NUREG/CR-5815  
BNL-NUREG-52311

# Evaluations of 1990 PRISM Design Revisions

Prepared by  
G. J. Van Tuyle, G. C. Slovik, B. C. Chan,  
A. L. Aronson, R. J. Kennett

Brookhaven National Laboratory

Figure 10. PRISM During RVACS Cooling Event (No Vessel Leak).

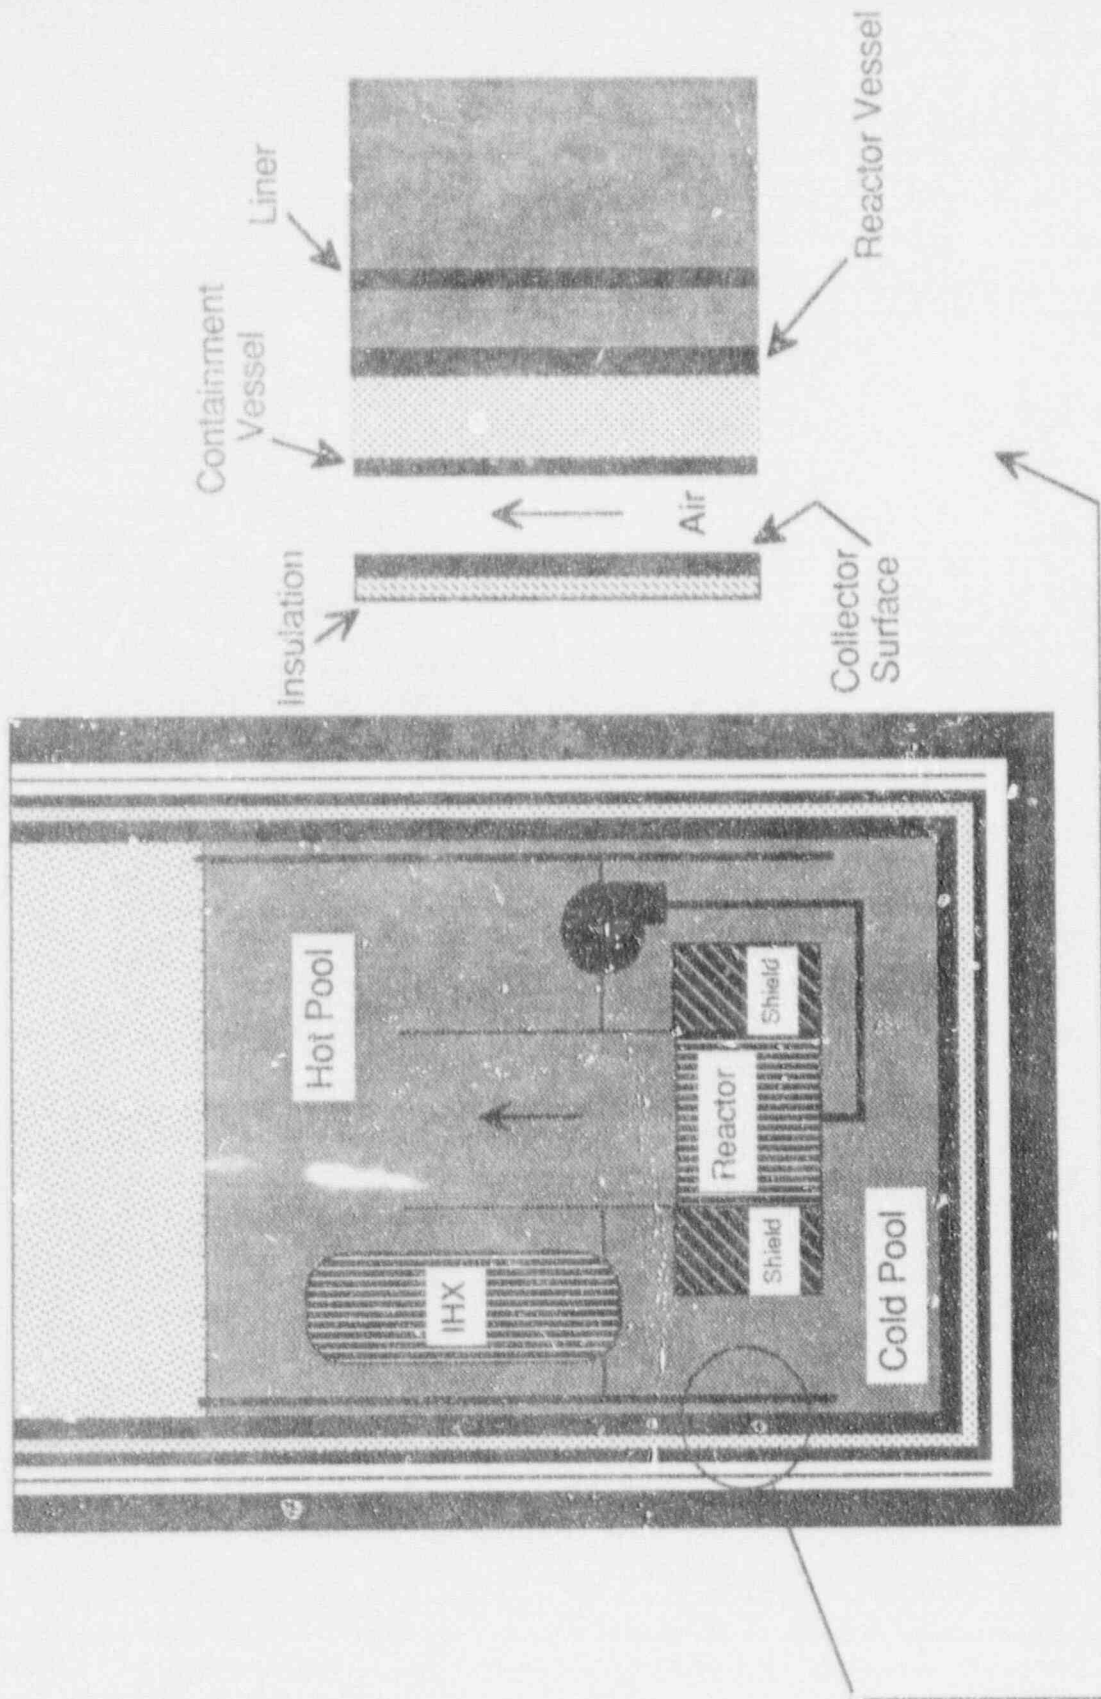
System conditions are as shown in Figure 10, a long term heat-up and eventually a spill begins. Once the hot pool sodium starts flowing down along the reactor vessel wall, RVACS performance is enhanced significantly. However, temperatures will continue to increase for several hours until the decay heat decreases and the RVACS performance increases enough for the system temperatures to level off. Only after several more hours would the decay heat level fall off enough for system temperatures to decrease.

Figure 11. PRISM LOHS with RVACS Performing Normally.

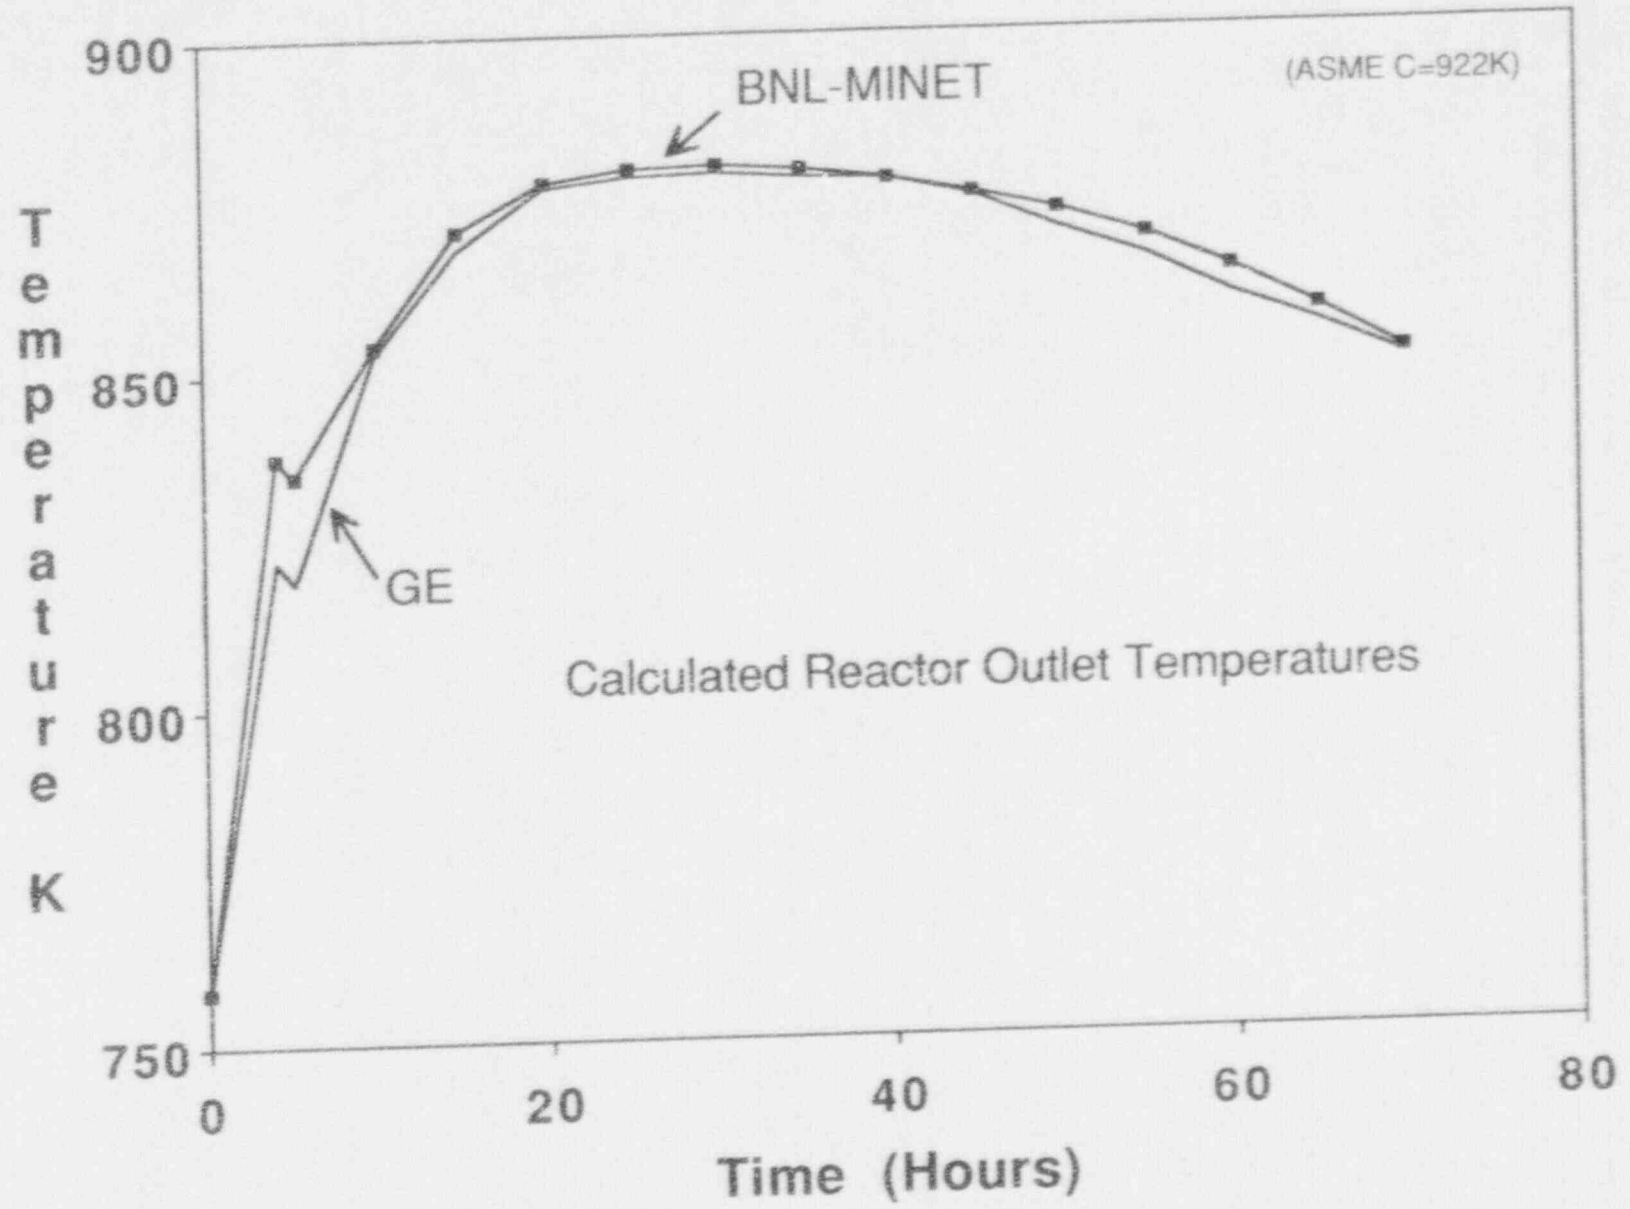
The predictions of the reactor outlet sodium temperatures during the reference RVACS event, in which the decay heat is removed solely through RVACS, are shown in Figure 11. It is noted that the peak sodium temperatures develop after 14 hours into the event, and are some 40+ degrees K below the ASME C limits for the reactor vessel. Both calculations are in excellent agreement regarding the peak temperature. There is also agreement as to when the sodium will expand enough for the spill-over to develop, about 4 hours into the transient. The difference in reactor outlet sodium temperatures at that time is believed to be due to a feature in the applicant's model that computes the heat transfer from the hot pool sodium, through the liner, to the sodium that remains stationary between the liner and the reactor vessel. Because there is no equivalent in the MINET model, the hot pool sodium remains a little hotter, and this propagates through the primary loop and results in reactor temperatures that are a little too high. However, once the spill-over begins, this difference disappears, and the calculations match up well after 8 or 9 hours into the event. Any differences in temperatures thereafter are not considered to be significant.

Figure 16. Peak Fuel, Clad, and Sodium Temperatures for 4 Key Bounding Events and Pertinent Limits for Fuel, Cladding, Structures, and Sodium Boiling.

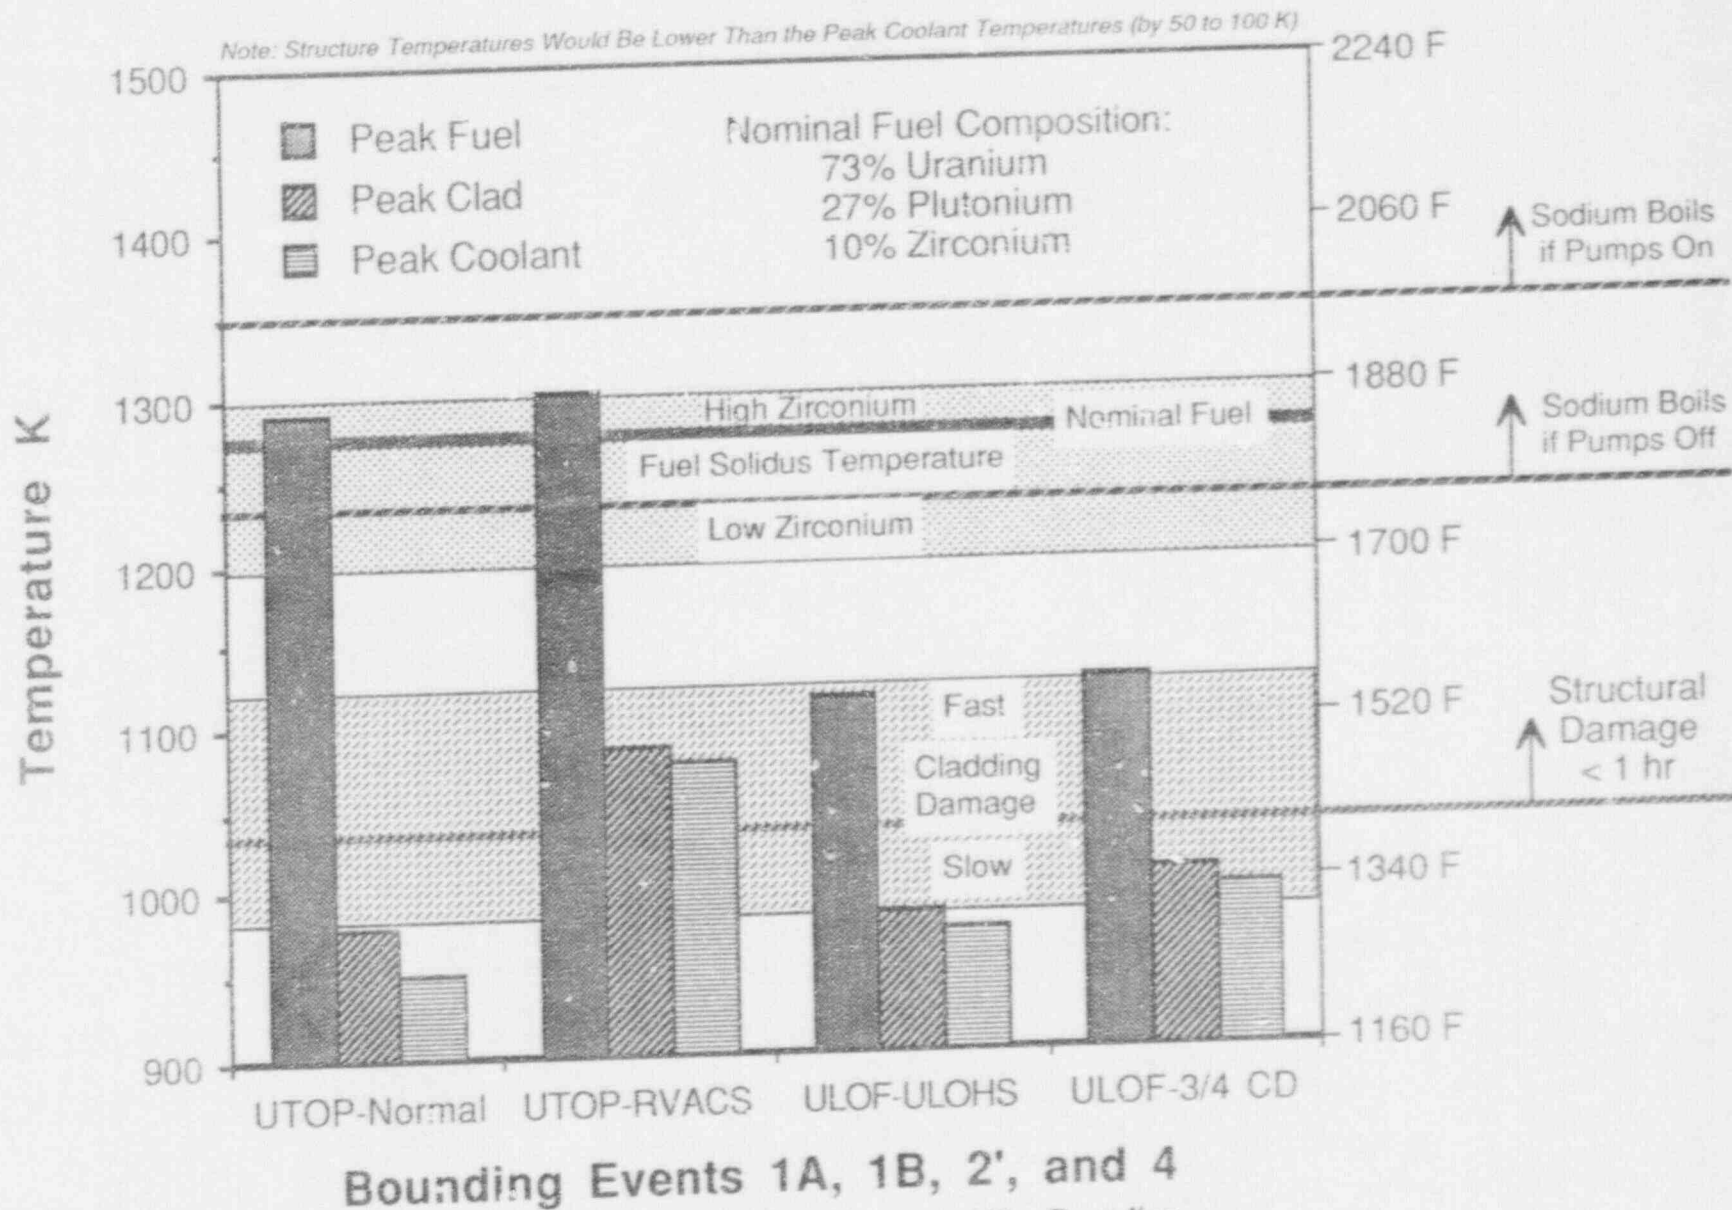
In order to better comprehend key portions of Table G.4.16-1 and other information contained within Section G.4.16, we constructed Figure 16. Included are the peak fuel, cladding, and coolant temperatures from GE's analyses for Bounding Events 1A, 1B, and 2' (GE analyzed a more challenging variation on the bounding Event 2 recommended by the NRC staff), and 4, along with some key information regarding failure limits (see also Section 4.16.3.2 regarding appropriate limits). In the interest of presenting a good overview on one figure, we have taken some liberties with the cladding damage range and the fuel solidus temperature range, and have packed more than the optimum amount of information into this single figure. However, the array of information provided by ANL regarding metal fuel performance and failure modes is a little overwhelming, and we feel that Figure 16 is not inconsistent with the information we have been provided (see also Section 4.16.3.2).

It is clear from Figure 16 that some fuel would be heated above the solidus temperature for Bounding Events 1A and 1B. For the UTOP events, the power production in the pins increase by about 70%, so the pin centerline temperatures can increase very substantially. As the peak fuel temperatures for 1A and 1B are above the solidus temperature for relatively high Zr fuel, there is little doubt that some localized melting would take place. Some policy decision will be required here, in terms of how much localized fuel melting will be acceptable.

The ULOF-ULOHS (Event 2') and ULOF-3/4 Coastdown (Event 4) events on the right side of Figure 16 result in significantly lower fuel temperatures. There may be a very slight amount of cladding damage for these events, especially if conservative limits (Section 4.16.3.2) are applied. The sodium is well below boiling, with or without pumping. A major factor in limiting the peak temperatures is the use of the GEMs to insert a large amount of negative reactivity once the pumps trip off line.

Despite ANL's optimism that they can demonstrate the metal fuel can survive these events, GE may have to consider reducing the potential UTOP initiator below 40 cents (including uncertainties), perhaps by moving the control rod stops more frequently. Because the applicant seems to have a few options available to reduce the potential UTOP initiators, the results summarized in Figure 16 are not viewed as an insurmountable problem.

Figure 48. Peak Fuel, Clad, and Sodium Temperatures for UTOP Events: GE's 1A, BNL's 1A with and Without Pu Migration, and BNL's UTOP/LOF

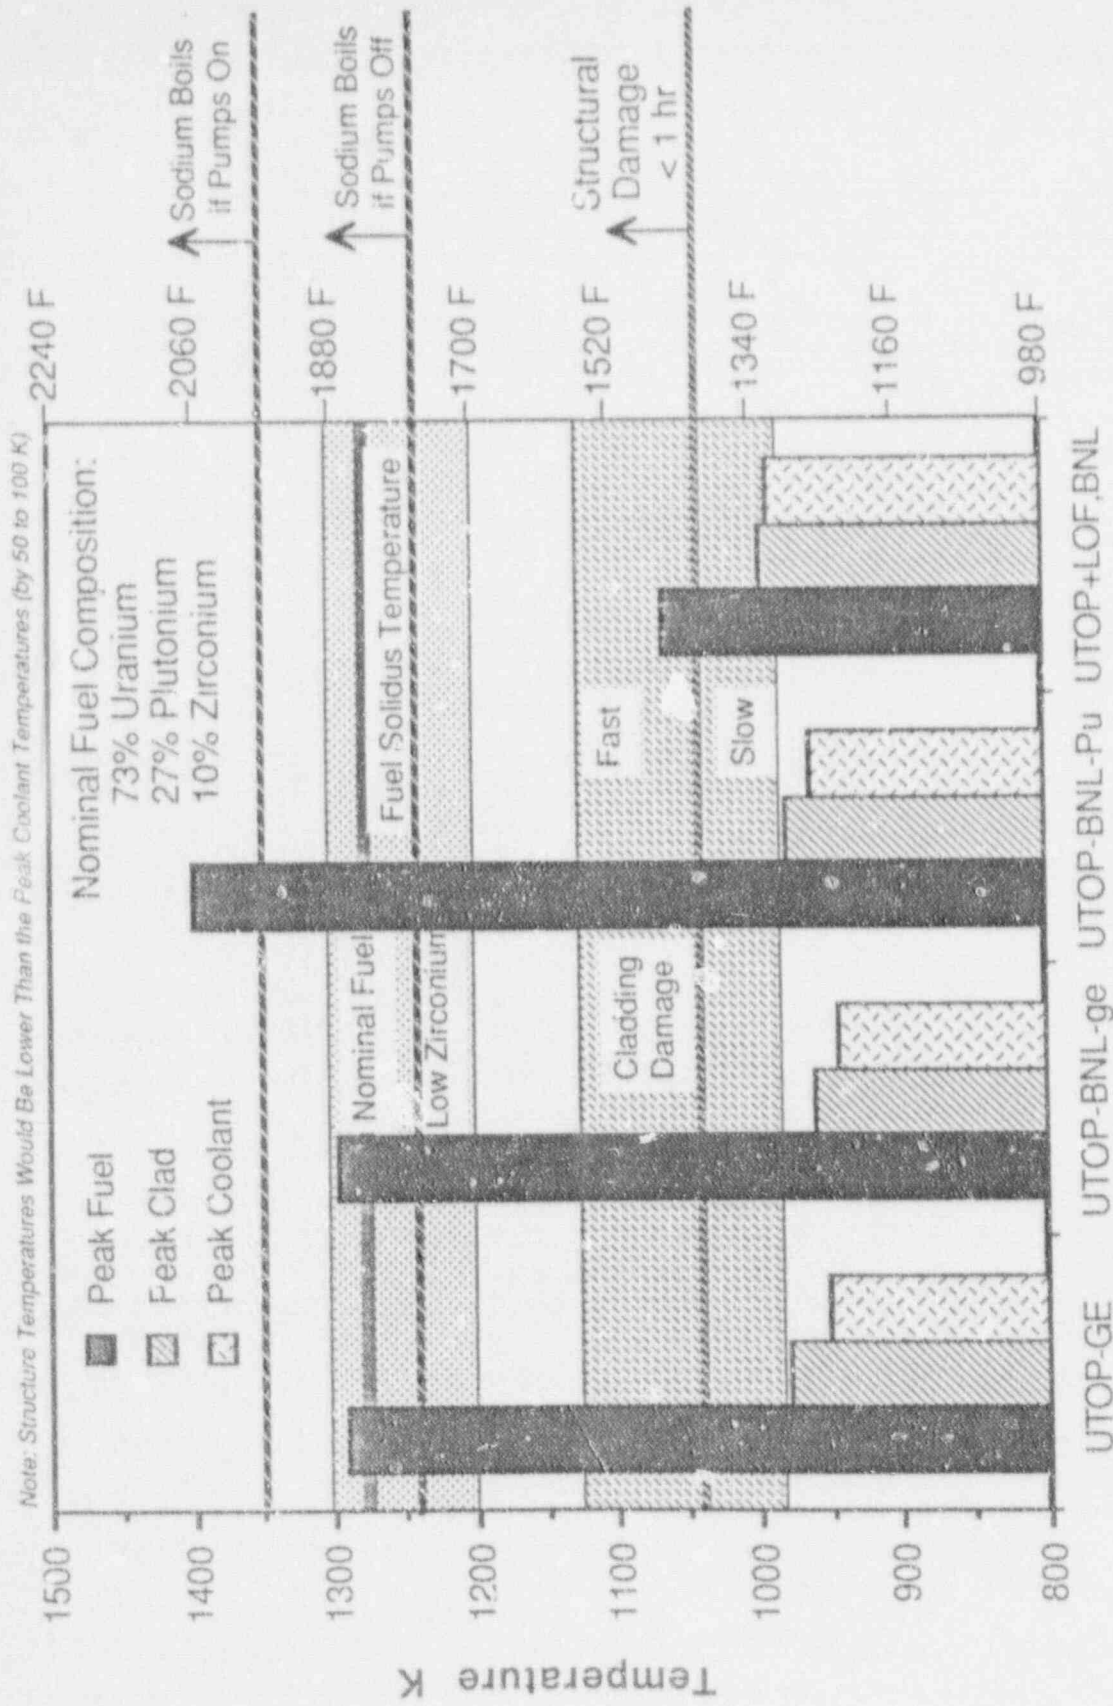
The peak temperatures predicted in the UTOP event calculations are shown in Figure 48, which also shows the pertinent temperature limits. As was discussed, the peak temperatures for the Event 1A 40c UTOP with the normal cooling were very similar, as long as we used GE's assumptions. Thus, the two sets of bars in the left half of Figure 48 are quite similar. Both calculations indicate some fuel melting in the hottest part of the core, although the damage would be pretty localized if nominal fuel is assumed. If zirconium migration is considered, the fuel damage would be more extensive. However, if the peak cladding and sodium temperatures appear to be acceptable, PRISM could probably survive the fuel melting if there was little or no effective compaction of the fuel material in the pins (a compaction would lead to increased reactivity and power production). However, if the lower cladding damage limit of 903K (Section 4.16.3.2) applies, then significant cladding damage could occur.

Peak temperatures for the same event, if we assume plutonium migration, are indicated by the third set of bars in Figure 48. The peak fuel temperatures are very high, although the peak clad and sodium temperatures are little changed. Even if the cladding remains intact, it appears that the fuel damage would be wide-spread and severe, assuming that plutonium migration is a genuine problem in the ternary fuel. Should further experiments indicate significant plutonium relocation, it may be necessary for GE to reduce the maximum credible TOP initiator.

The final case in Figure 48 is an instance where the design changes have resulted in enhanced safety, as this was previously one of the more hazardous unscrammed events. However, the addition of the GEMs has significantly improved PRISM response, and the principal concern remaining would be
